Community projects - South Kanara Area -
Block II - Drinking water supply - Improvements
to the existing well at Kotekani in Padu
Village (Sajipattu) - Estimate - sanctioned.

Sub: Community Projects - South Kanara - Drinking Water Supply - Construction of a well in Sajippadu Village - Estimate - Sanction - Requested.

Sub:- COMMUNITY PROJECTS - South Kanara Area - Block II - Drinking Water Supply — Improvements to the existing well at Kotekani in Padu village — Completion report.

Completion Report.

PLAN OF PROPOSED WELL IN DAJJEPEDU KOTEKANI IN S.No 75/2.

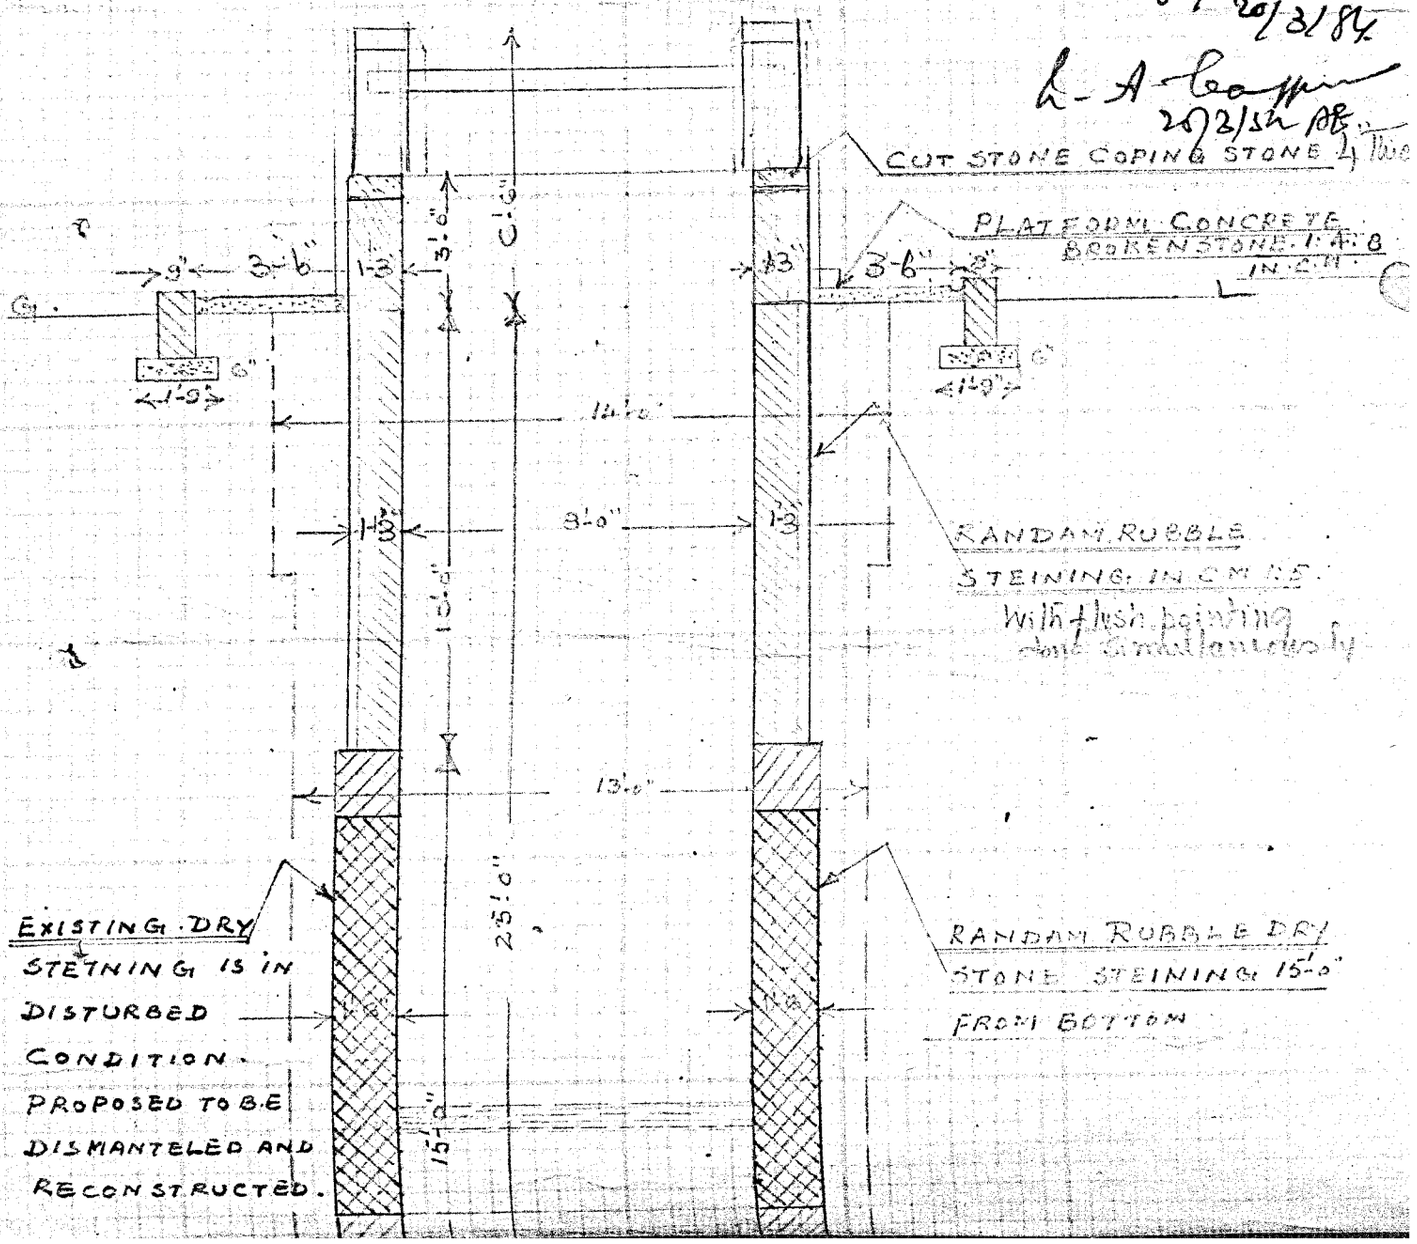
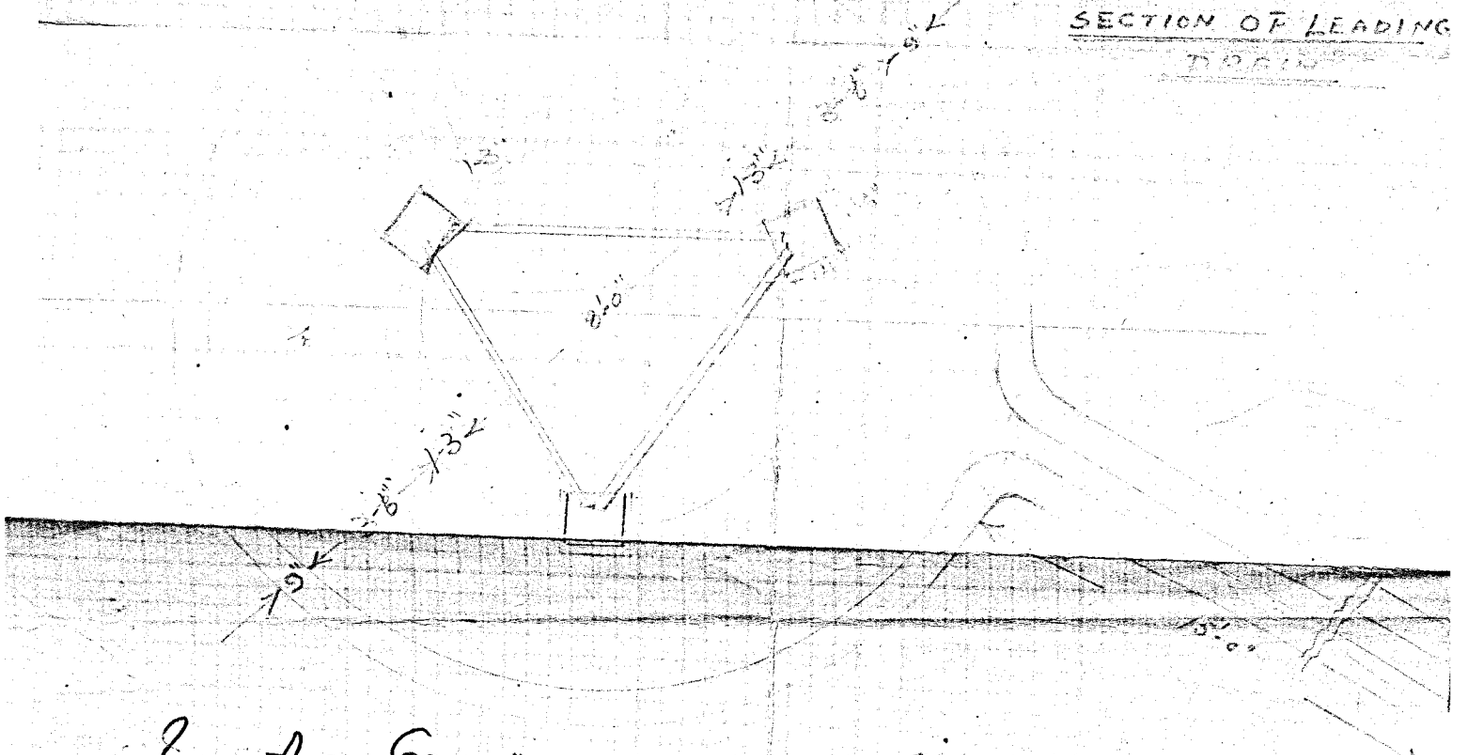
Certified that work has been executed and completed as per plan and all the alterations details have been corrected and shown in red ink.

Certified that the work has been executed as per sanctioned plan and deviations noted in CR
